Browns Summit Creek Restoration Project Year 6 Monitoring Report

DMS Project ID No. 96313, DEQ Contract No. 5792

Subject: Response to Task 12 Draft Year 6 Monitoring Report Comments for Browns Summit
(DMS #96313) Cape Fear River Basin; CU 03030002; Guilford County, North
Carolina Contract No. 005792

Figure 4.1
Current Conditions
Plan View
Browns Summit Site
(DMS #96313)

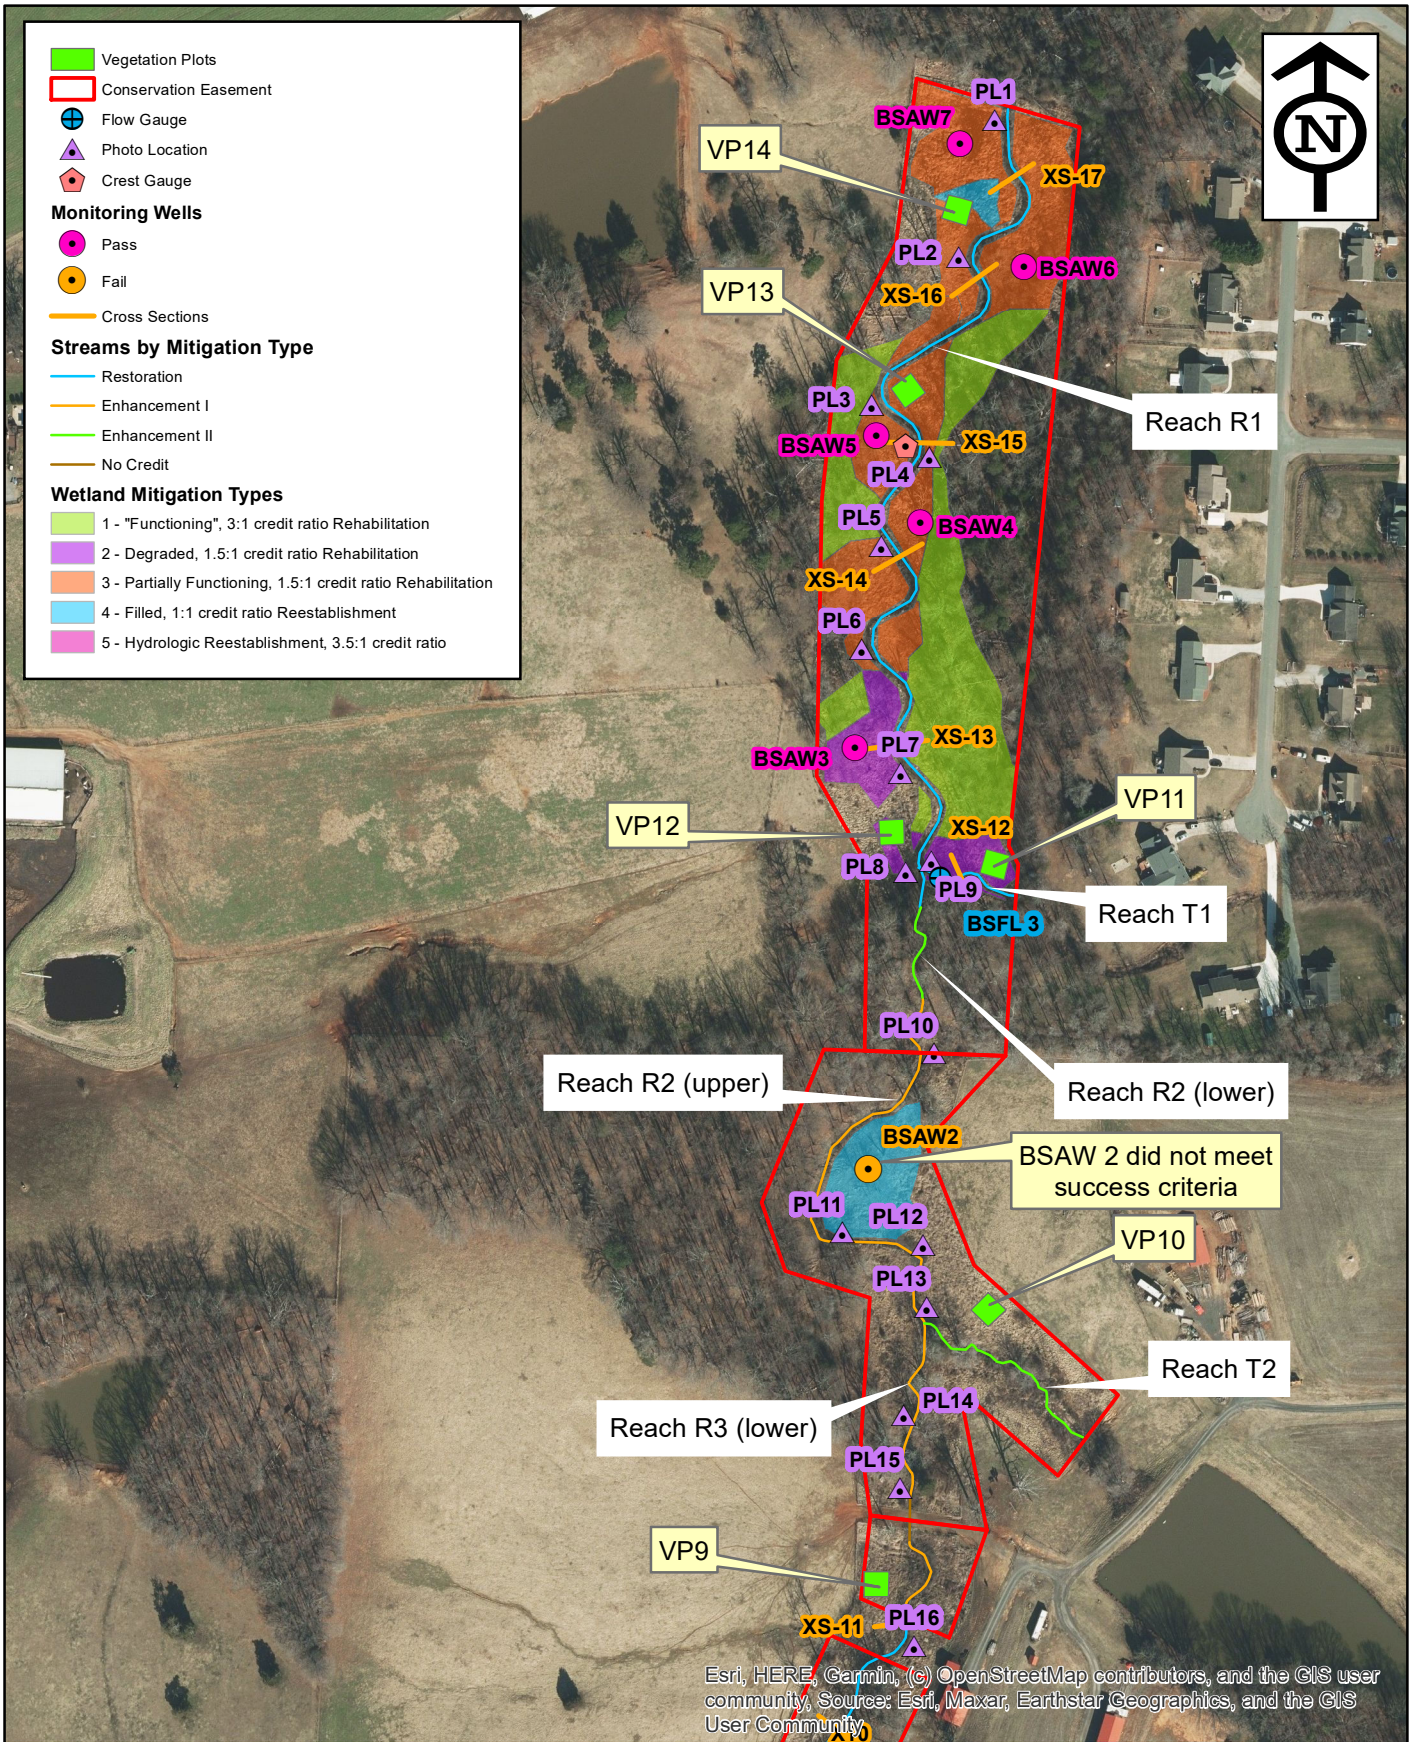
Comment: Figure 4.1: Color code monitoring wells to indicate which are meeting success/not meeting success.

Response: Revisions have been made as requested.
